SUBMISSION ON THE MRCP AND ERL

SUBMISSION ON THE ERA'S CONSULTATION PAPER

**Wholesale Electricity Market – Submission to Procedure Change Proposal PC_2011_06
Five Yearly Review of the Methodology and Process for Determining the Maximum Reserve Capacity
Price**

Five Yearly Review of the Methodology and Process for Determining the Maximum Reserve Capacity Price (MRCP)

Graph 1: Merredin Energy – Open Cycle Gas Turbine S-curve

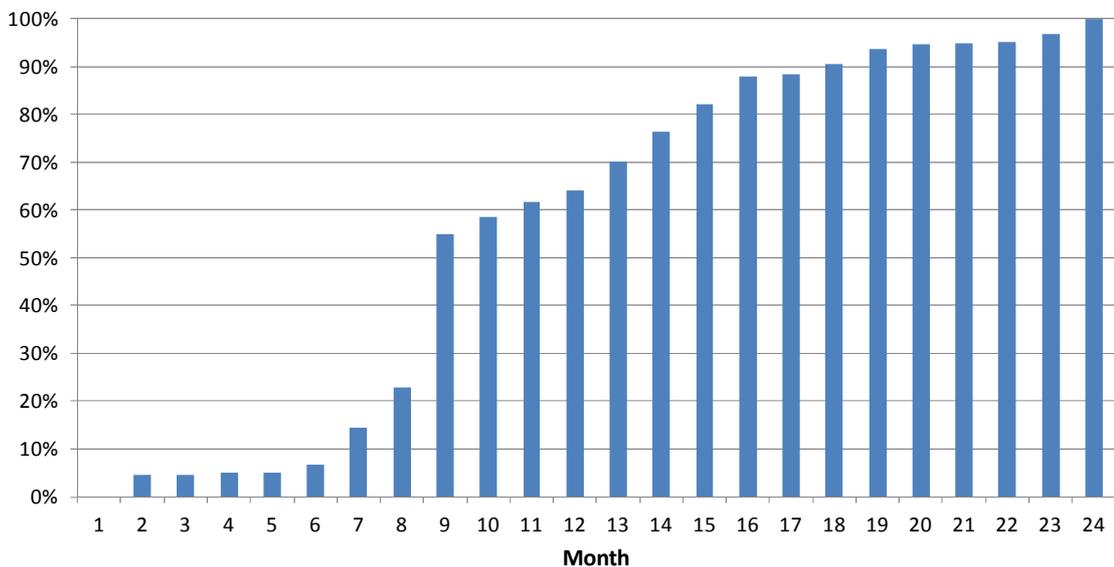
Merredin Energy’s view is that even a nine month mid-point spend is overly aggressive. The S-curve for the total project costs involved in commissioning our 82MW open cycle peaking generator is set out in Graph 1 below.

Significant costs under the Interconnection Works contract with Western Power were incurred in month 8 and in month 13. By the end of month 8, almost one-quarter of total project costs had been incurred. Around 30% of total project costs were incurred in month 9 due to significant instalment payments to General Electric for turbine units and to the EPC contractor for the balance of plant works.
